Re: Comments on Behalf of Atchafalaya Basinkeeper, Gulf Restoration Network, the Louisiana Crawfish Producers Association-West and the Delta Chapter of Sierra Club regarding the proposed Buffalo Cove Management Unit – Element 10 and Draft Environmental Assessment (EA #441) for the Atchafalaya Basin Floodway System, Buffalo Cove Management Unit

ABK – GRN – LCPA-West – Sierra Club Delta Chapter Comments re: Buffalo Cove Management Unit – Element 10 and EA #441

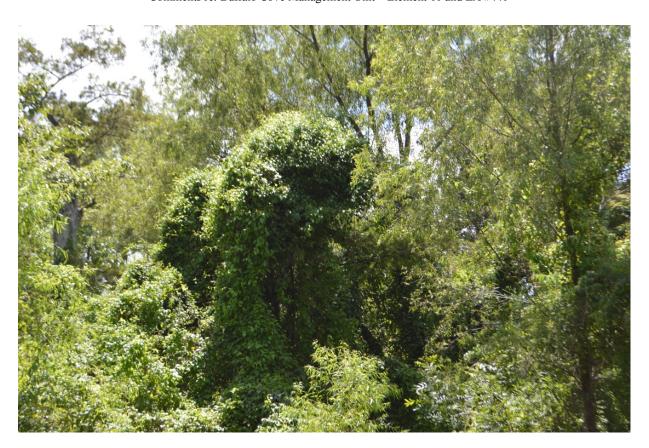
Unfortunately, this does not accurately reflect the ongoing trends on the ground. The wetlands are already filling in at a rapid rate due to sediment accretion, however, cypress-tupelo are not "dying out." Rather, as accretion elevates the Basin floor, cypress and tupelo are being replaced by hardwood species. The project has increased the amount of river sand and silt introduction into the area, and areas that used to be shielded from this sediment introduction are being lost at an alarming rate.

While decreased water levels due to accretion may increase cypress seedling survival, a decrease on the amount of time that those forest are flooded promotes the growth of plants that will outcompete cypress, like swamp privot, water helm, lady's ear drop vines and eventually hardwood trees. Nearly all accreted areas in the Basin are either a big thicket of vines and bushes or hardwood forests.

The three photos below were taken on July 14, 2018 on the east-side of the Atchafalaya Basin on an accreted swamp along Bayou Canon at the following coordinates: 30° 07'12.34" N 91° 21'49.15" W. These photos depict a common result of accretion whereby the elevated basin floor promotes the growth of plants that outcompete cypress. In these photos you can see that the cypress forests are being taken over by lady's ear drop vine as a result of accretion.

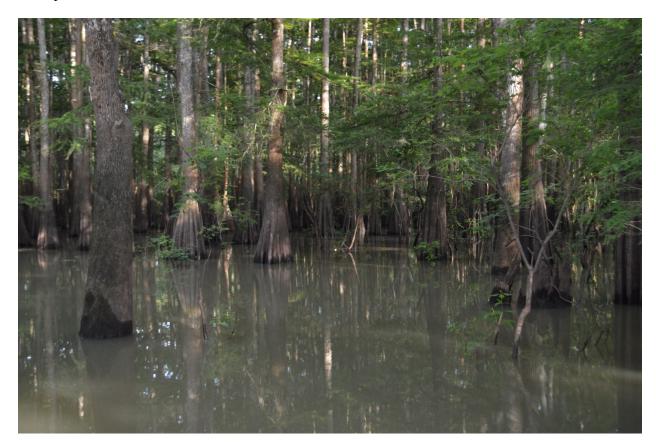
Element 16 is bringing huge amount of sand and silt, filling swamps and what is left of Bayou Eugene an at alarming rate. Approximate coordinates: 30°03'14.45" N 91°34'19.18" W

The first picture depicts the swamps closer to Bayou Eugene holding water. The following pictures depict swamps filled by sand. The pictures are in order, coming from Bayou Eugene toward the canal that is the sediment source created by the Corps. Notice how the amount of sand increases as we move toward the sediment source. Notice bushes and willows taking over as the cypress swamp fill with sand and silt.

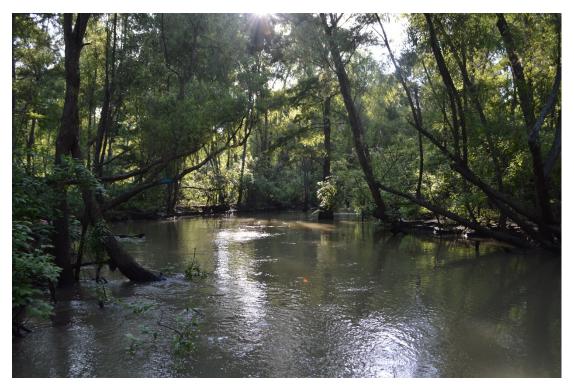
The first picture shows water full of sand and silt moving from the cut into Bayou Eugene. Despite the higher than normal water levels, Bayou Eugene was very shallow and will go almost completely dry during the dry season. Hardly a deep-water habitat for fish.
